# Technical Service Bulletin

## 68 Noises from the center console when in contact with the knee

68 22 40 2068592/1 November 17, 2022.

Model(s)	Year	VIN Range	Vehicle-Specific Equipment
e-tron quattro	2019 – 2023	All	Not Applicable
e-tron Sportback quattro	2021 – 2023		
e-tron S	2022 - 2023

**Figure 1.** Apply fleece adhesive tape (approx. 3/8" long, folded over).

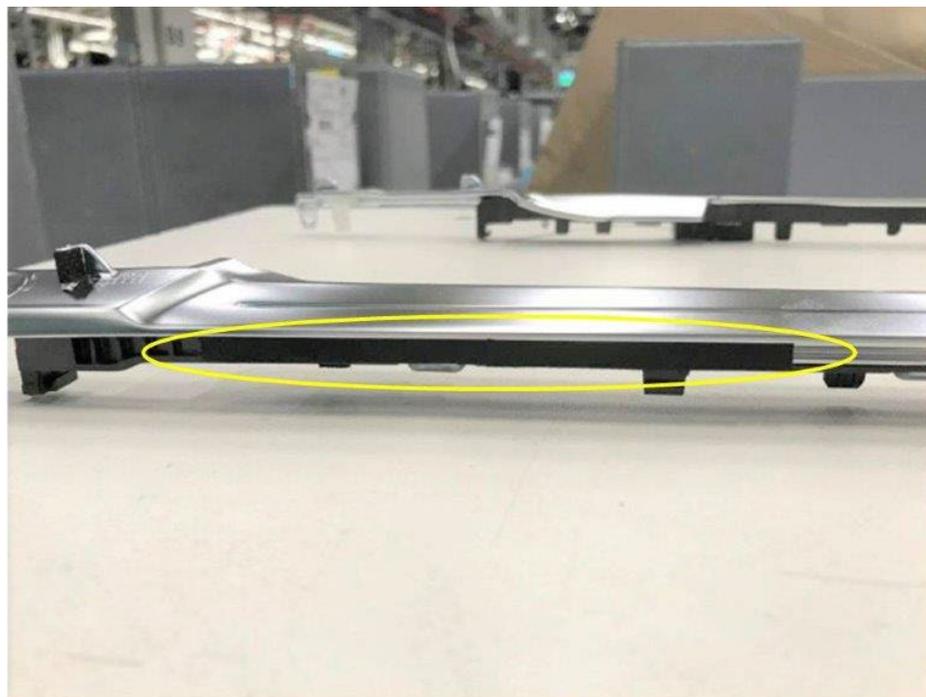
- Relative movement between trim/light bar and center console results in noises.

Relative movement between trim/light bar and center console results in noises.

1. CW42/2020 (Figure 2).
2. CW34/2022 (Figure 1).

1. Remove the center console decorative trim according to:  
*Elsa >> Repair manual >> Body >> Body Interior >> 68 Interior Equipment >> Center Console >> Center console Decorative Trim, Removing and Installing.*
2. Apply fleece adhesive tape to the trim/light bar as shown (figures 1, and 2).
